S16 Planning Application for Proposed Hospital Redevelopment with Minor Relaxation of Building Height Restriction in “Government, Institution or Community (7)” Zone and Areas Shown as ‘Road’ at Blocks A, B and C of Hong Kong Baptist Hospital, 222 Waterloo Road, Kowloon Tong, Kowloon

Responses to Comments

COMMENTS FROM RELATED DEPARTMENTS

Photo Record of Site Survey

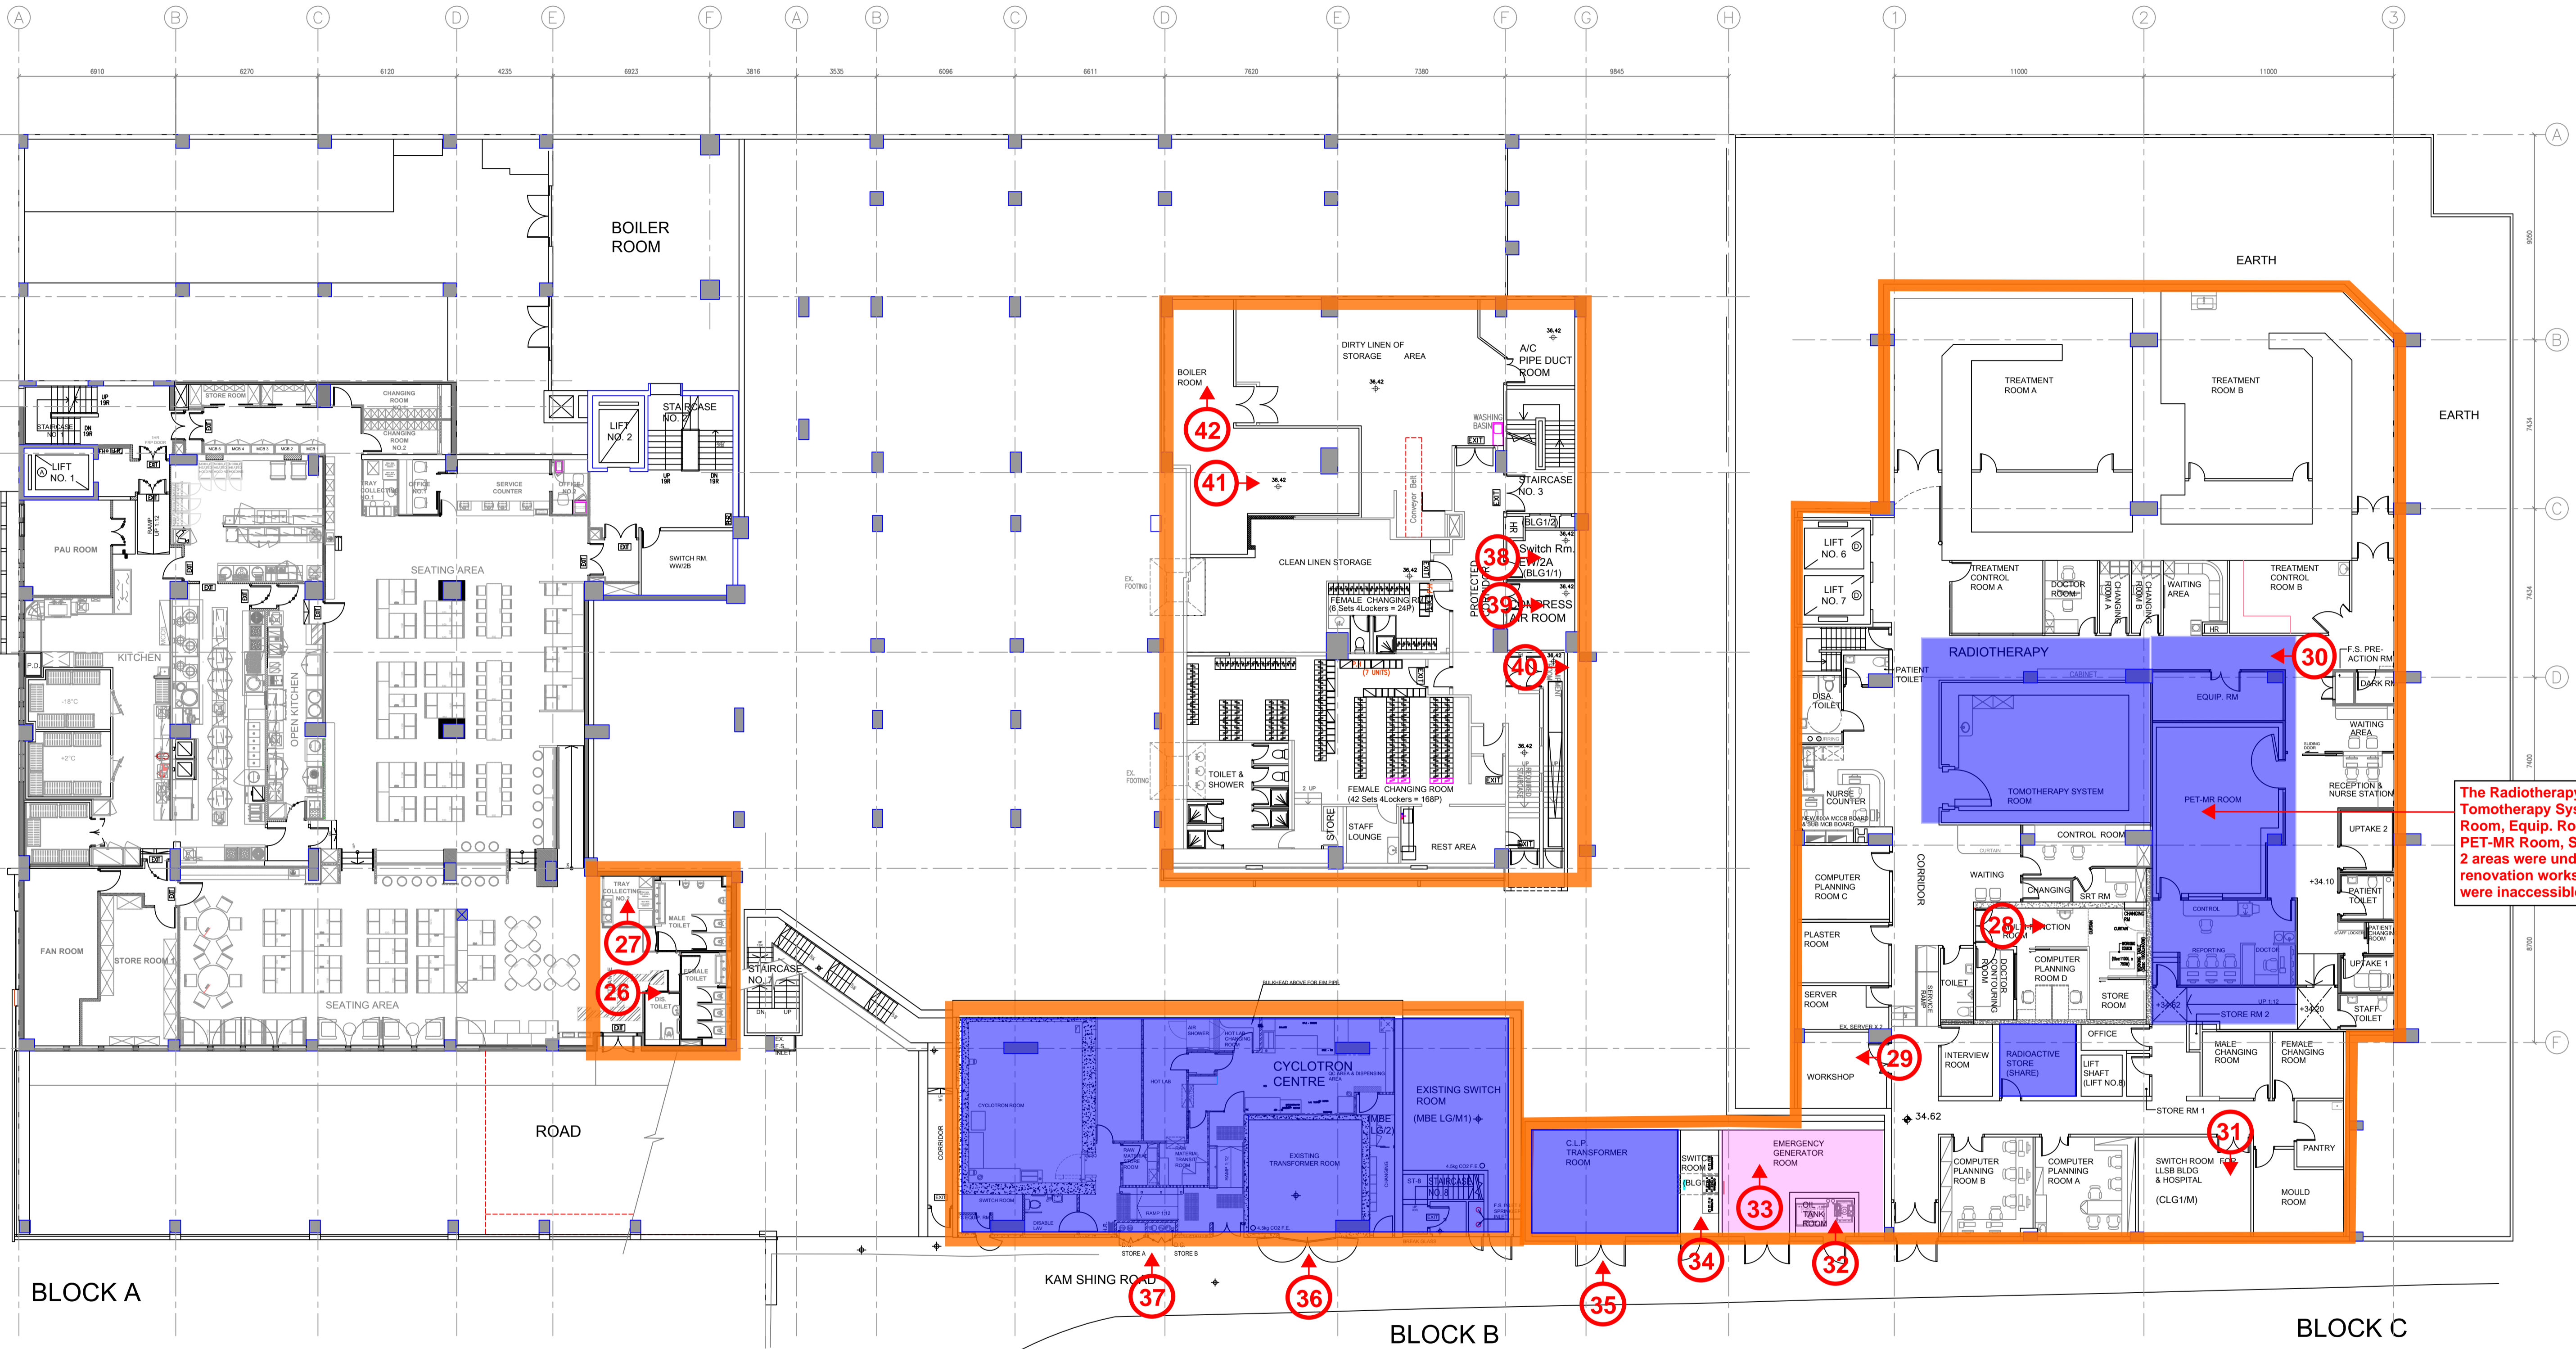
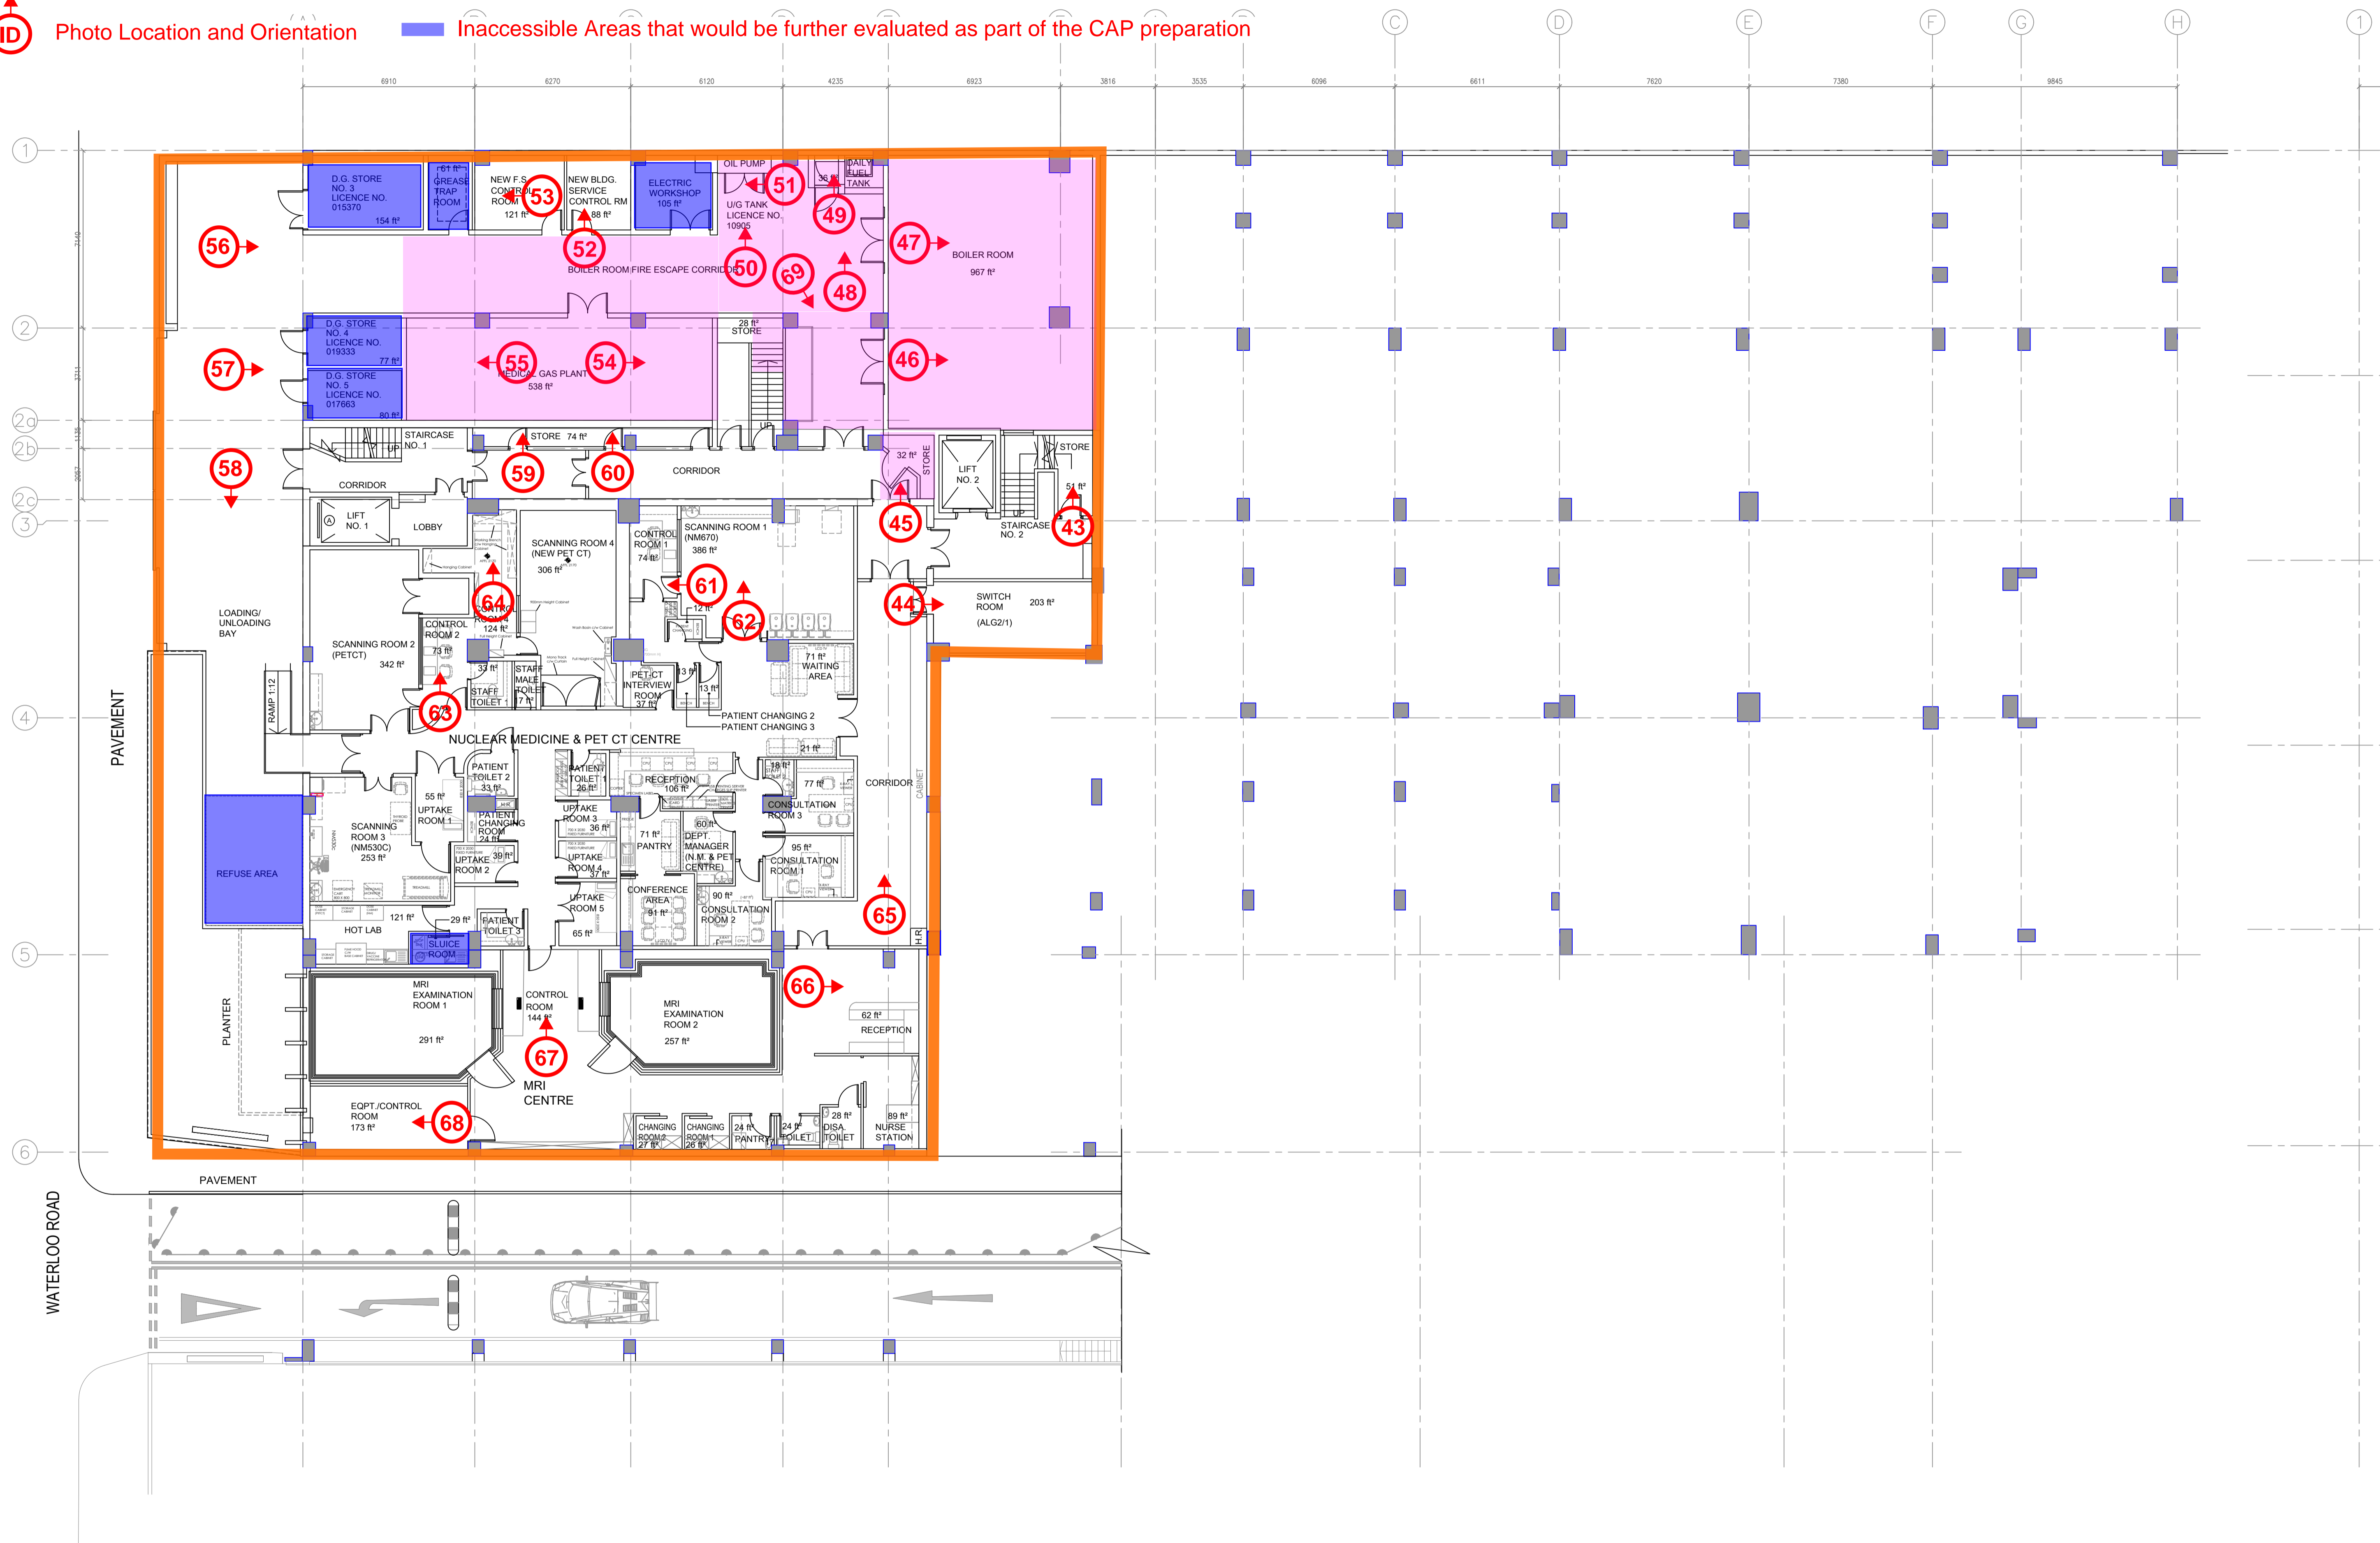
No.	Comments	Responses
	<p>there are potential leakage and spillage concerns for the associated oil pipes.</p> <p>(b) Please clarify the nature of the underground tank at LG/2 as captured in Photo ID 50.</p> <p>(c) The Consultant is advised to graphically indicate the location of areas identified with land contamination potential during the site appraisal and the inaccessible locations that would be further evaluated as part of the CAP preparation.</p>	<p>Noted. The nature of the U/G tank at LG/2 is clarified to serve as a U/G Fuel Oil Service Tank. S.7.4.1.5, Table 7.2, and Table 7.3 of the revised EAS Report (Appendix B) is updated accordingly.</p> <p>Noted. The inaccessible locations that would be further evaluated as part of the CAP preparation has been graphically indicated in Appendix 7.2 of the revised EAS Report (Appendix B). The graphical indication of areas identified with land contamination potential is now appended in Appendix 7.2 of the revised EAS Report (Appendix B).</p>
